**Subject: Vermont Yankee Nuclear Power Station
License No. DPR-28 (Docket No. 50-271)
Technical Specification Proposed Change No. 260
Intermediate Range Monitor Surveillance Test Frequencies**

Proposed Technical Specification Change No. 260

Intermediate Range Monitor Surveillance Test Frequencies

Marked-up Version of the Current Technical Specifications

TABLE 4.1.1

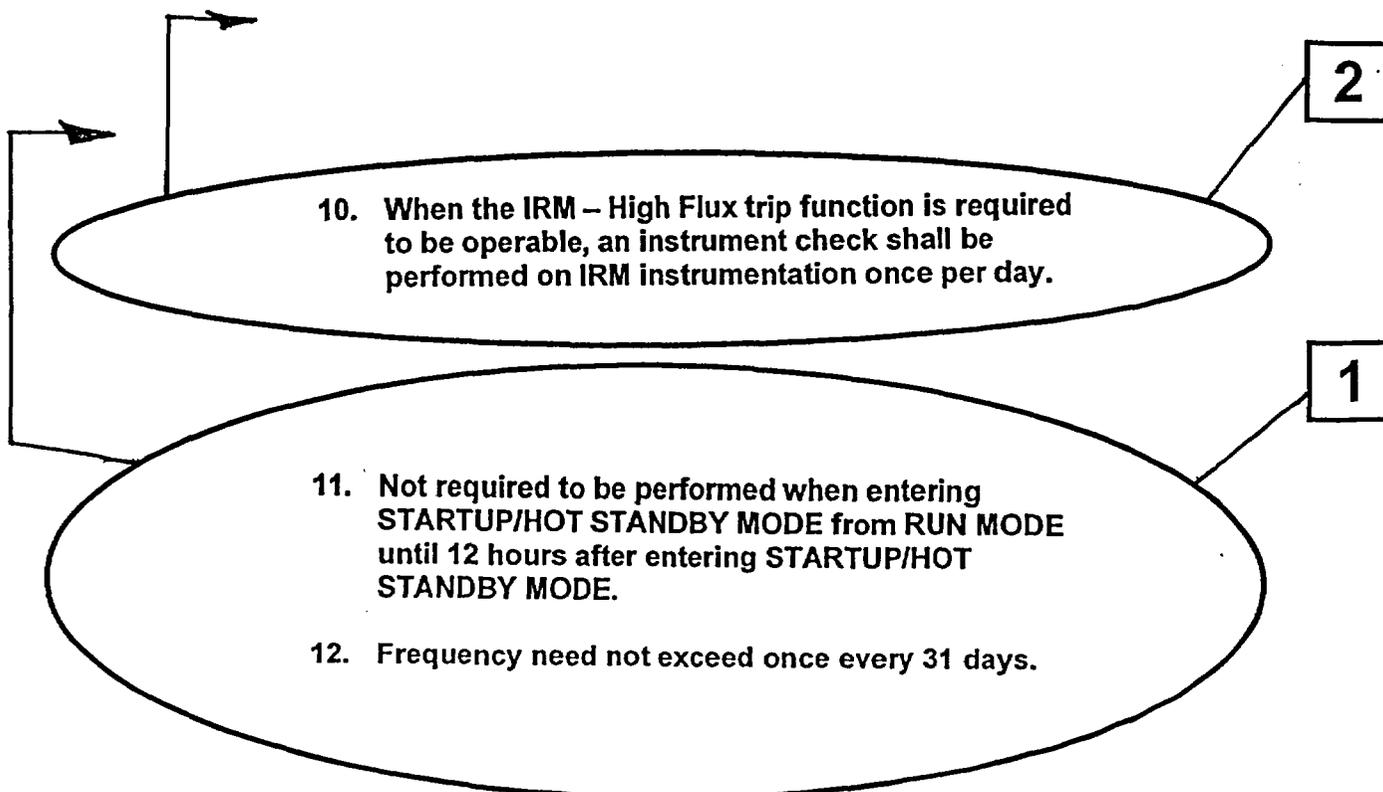
2

(10)

~~Before Each Startup & Weekly
During Refueling⁽⁶⁾~~
~~Before Each Startup & Weekly
During Refueling⁽⁶⁾~~

Before and During
Each Startup & Once
Every 31 Days During
Refueling^{(11) (12)}

1

10. When the IRM-High Flux trip function is required to be operable, an instrument check shall be performed on IRM instrumentation once per day.
11. Not required to be performed when entering STARTUP/HOT STANDBY MODE from RUN MODE until 12 hours after entering STARTUP/HOT STANDBY MODE.

12. Frequency need not exceed once every 31 days.

TABLE 4.1.2

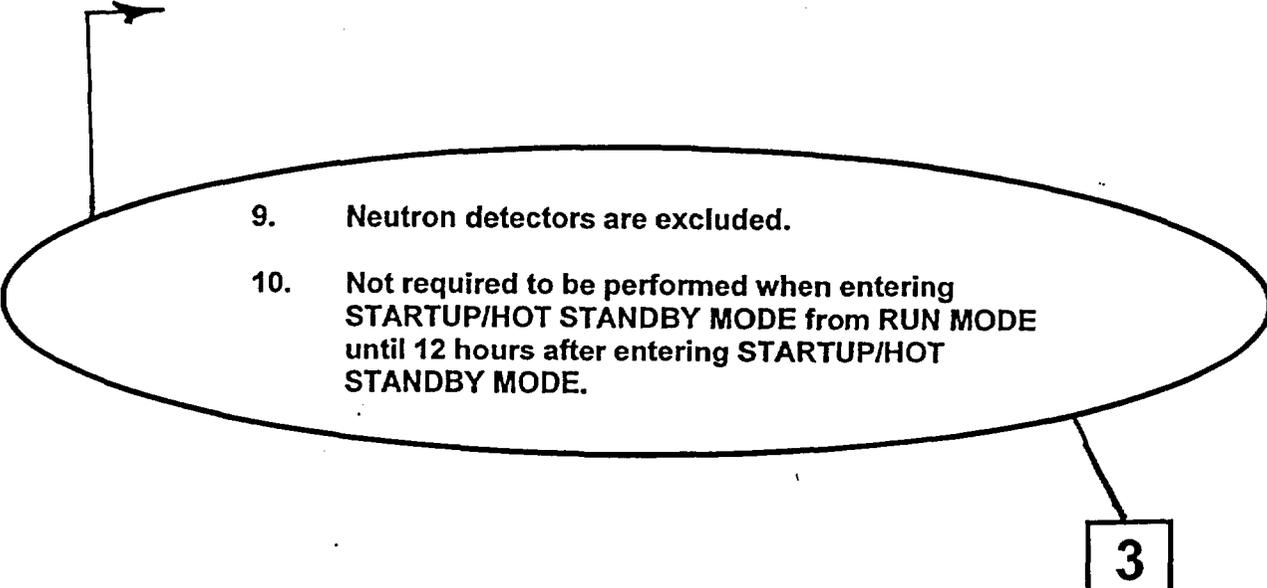
Main Steam Line Isolation Valve Closure	A	(6)	Refueling Outage
High Flux IRM Output Signal (7)(9)(10)	C	Standard Voltage Source	Once/Operating Cycle

3

10. Not required to be performed when entering STARTUP/HOT STANDBY MODE from RUN MODE until 12 hours after entering STARTUP/HOT STANDBY MODE.
